TOSHIBA AMERICA CONSUMER PRODUCTS, INC

TOSHIBA	VCR / CAMERA SERVICE BULLETIN NO: 68
DATE: November / December 1992	MODELS: M-458, M-468, M-657, M-658, M-668, M-758
SUBJECT: S-Soft Brake Lever

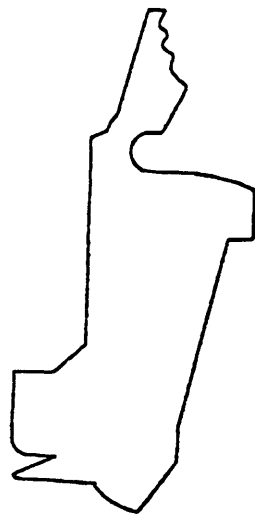
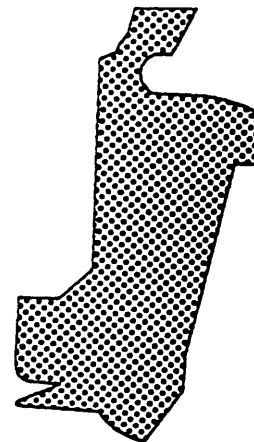
Symptom: Will not play due to loading malfunction.

**White
(Previous)**

**Black
(Current)**

Corrective Action: Replace the soft brake lever K128 with the new black colored one.
